**Reference: Appleton Shores  
Response to Mississippi Valley Conservation Authority Comments  
Our File No.: 114165**

The following is in response to the Mississippi Valley Conservation Authority (MVCA) comments on the following report, which was submitted with the Draft Plan of Subdivision application.

- Appleton Shores Subdivision Servicing Options and Conceptual Stormwater Management Report, prepared by Novatech, dated September 2, 2022.

FIGURE 114165-FPM

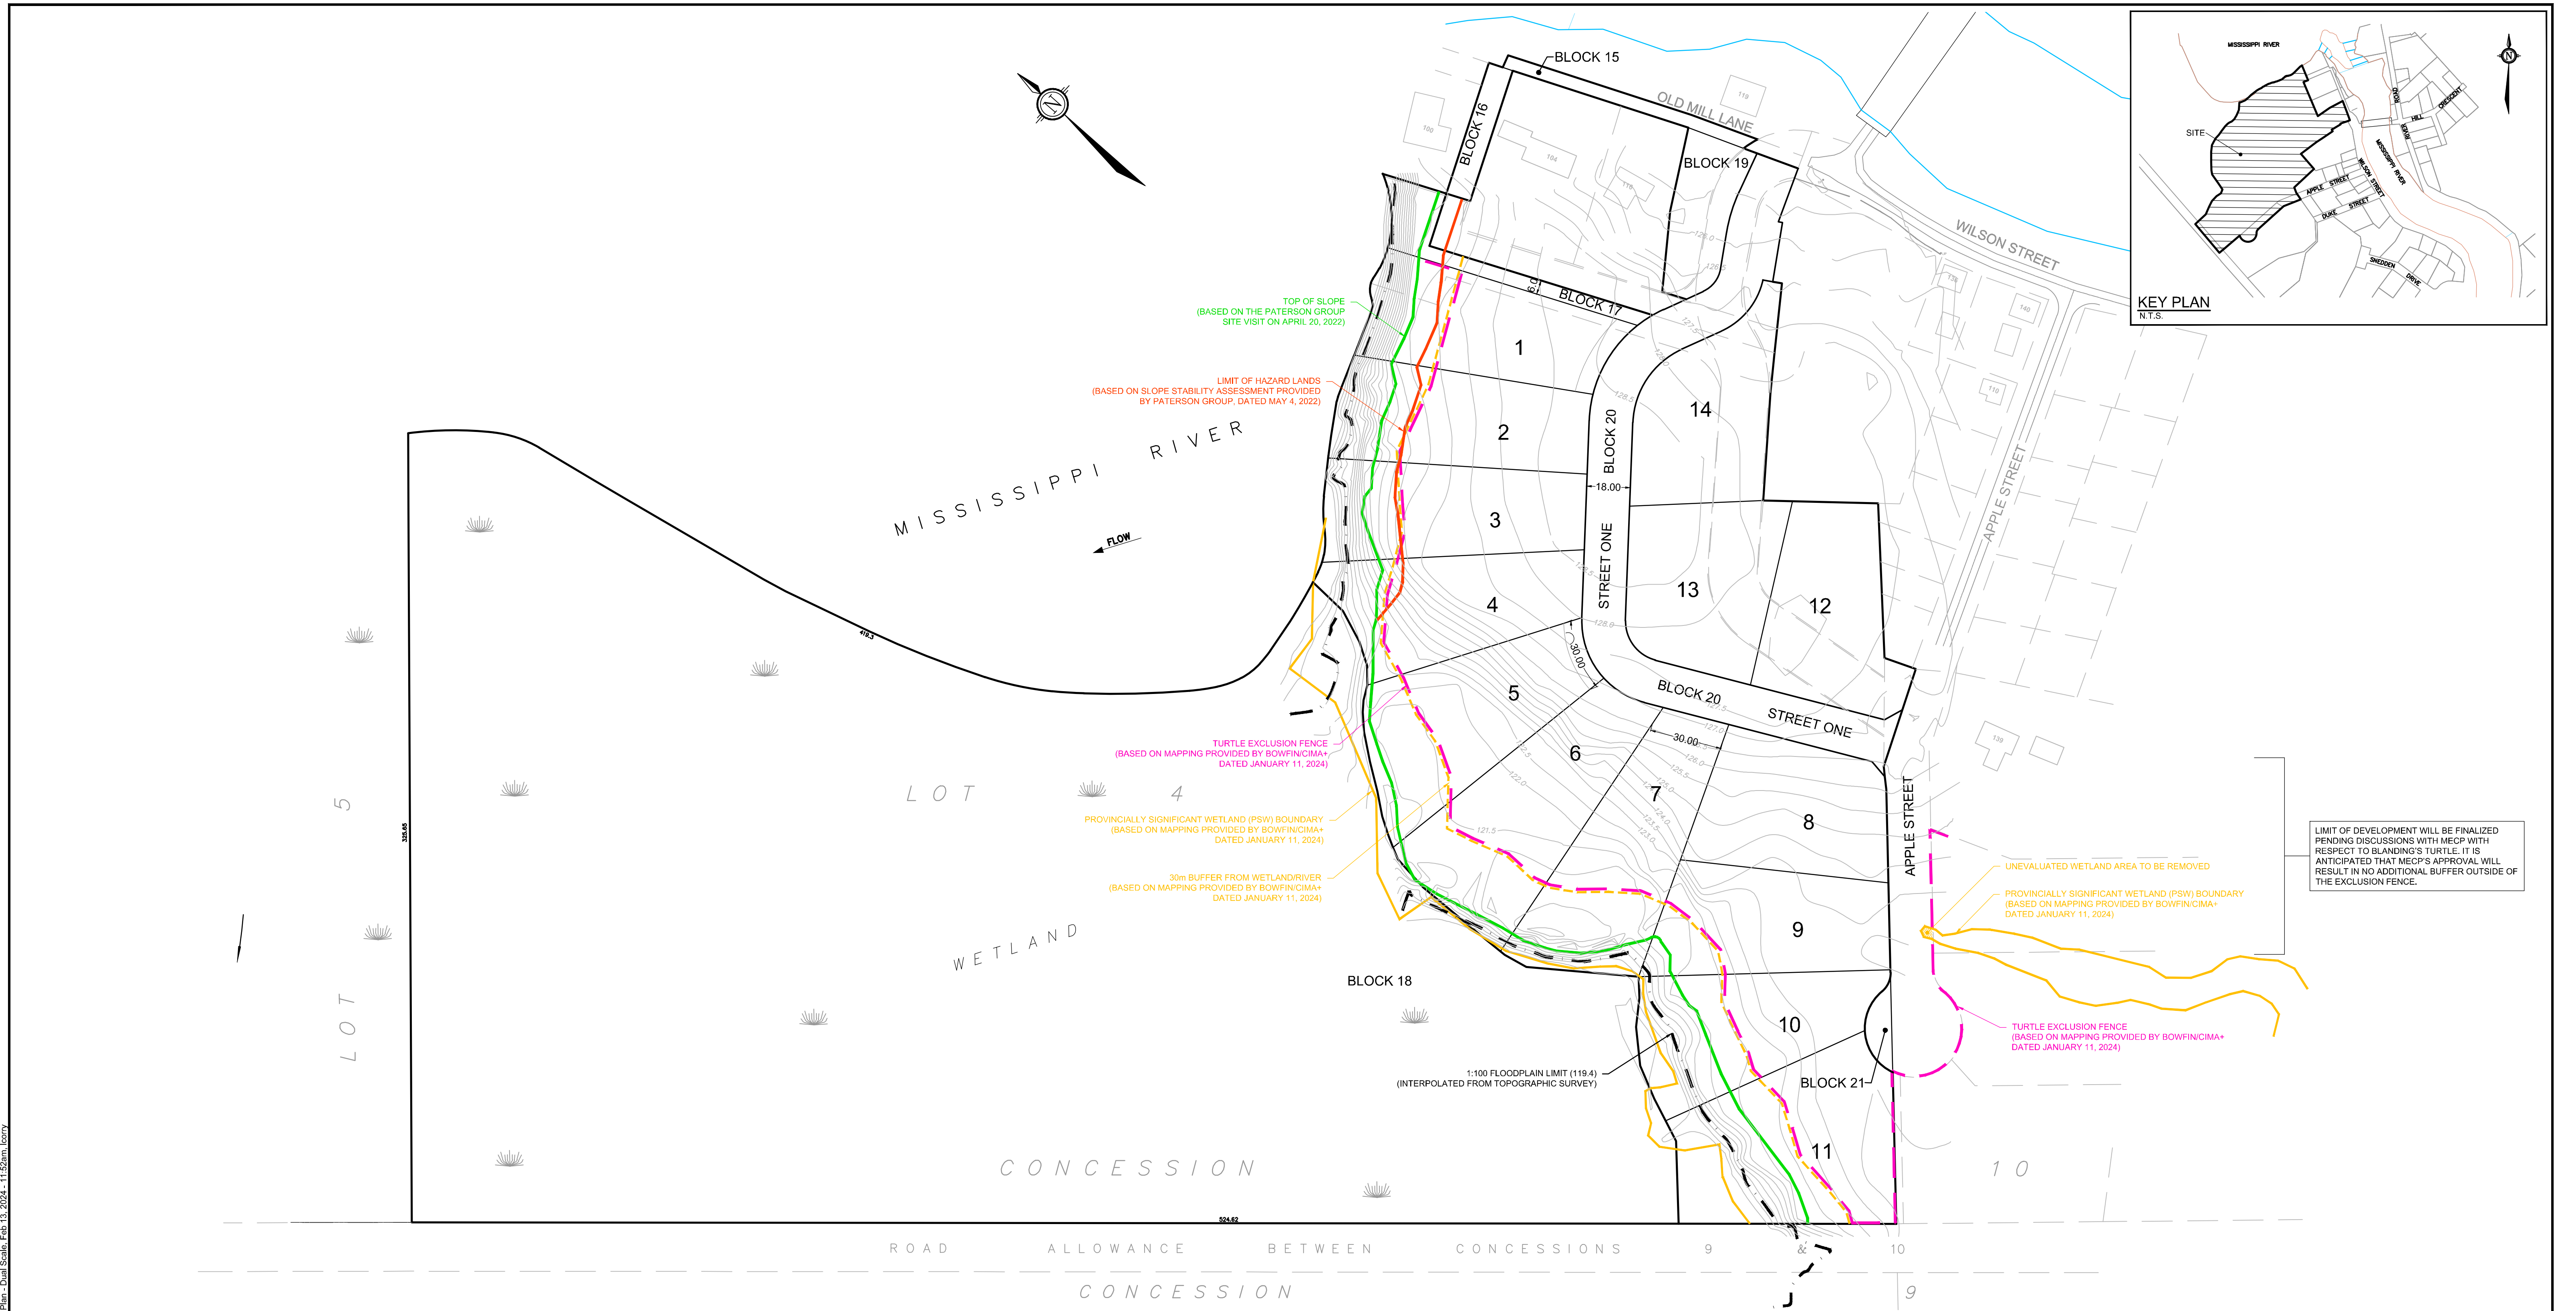
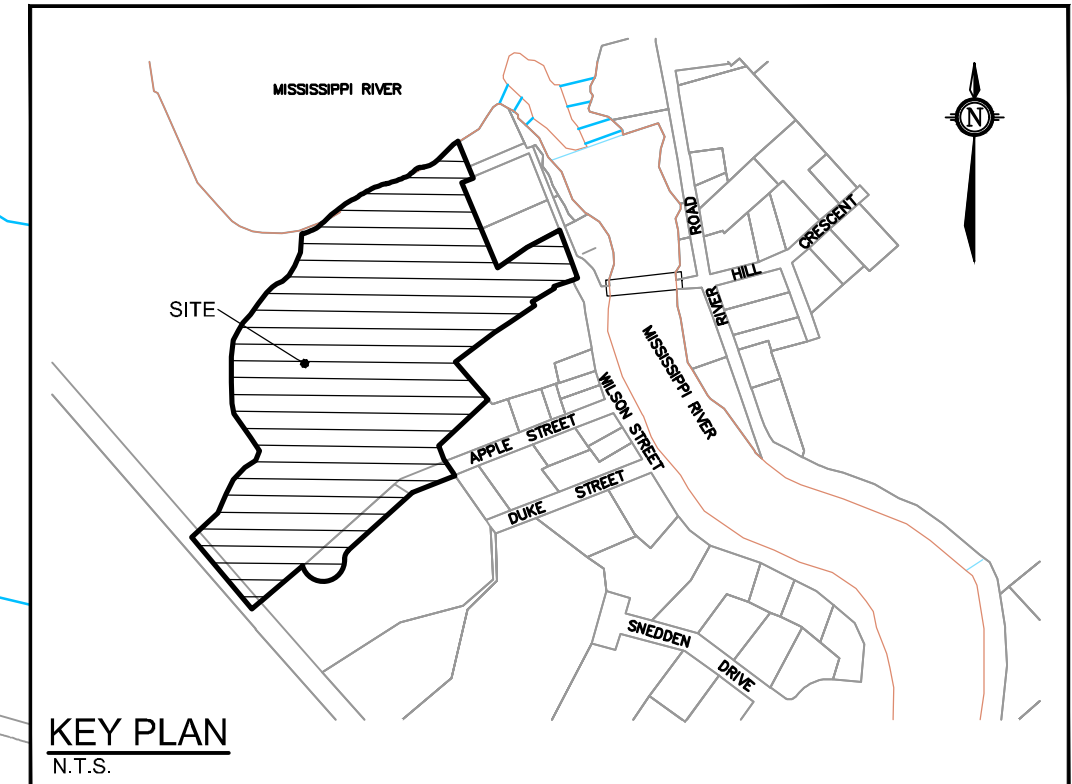
- 4) **MVCA Comment:** The post-development drainage area plan shows the 100-year flood elevation as 119.8m (interpolated from the topographic survey). However, MVCA completed a floodplain mapping study for the Mississippi River in 2019 (updated in 2022); per the study, the 100-yr flood elevation within the subject site is 124.8 – 124.82 m. Using the 100-yr flood elevation from the floodplain mapping study is recommended in designing the SWM plan.

*We have prepared a figure to demonstrate the subdivision location relative to the MVCA's updated 100 year regulatory flood elevations (Figure 114165-FPM, February 2024, attached). The 124.8 to 124.82m elevations referenced in the MVCA's comment are upstream of the dam. The cross-sections downstream of the dam are elevation 119.4m.*

*West side of subdivision:*

*The 119.8m flood line shown on the Post-development Drainage Area Plan is from information we received from the MVCA in 2016. The newer 2022 mapping was provided to us in November 2022, after completion of our September 2022 report.*

*The newer mapping shows the 100 year elevation at 119.4m. We have updated the Concept Plan (now 114165-CP2021, rev.7) accordingly and have attached a copy. As the newer elevation is lower, it does not affect the conclusions of our September 2022 report. We will, however, make the update to elevation 119.4m in our detailed design report.*

*East side of subdivision:*

*Floodplain mapping upstream of the dam shows an elevation of 124.8m. The flood plain in this area is outside the limits of the subdivision.*
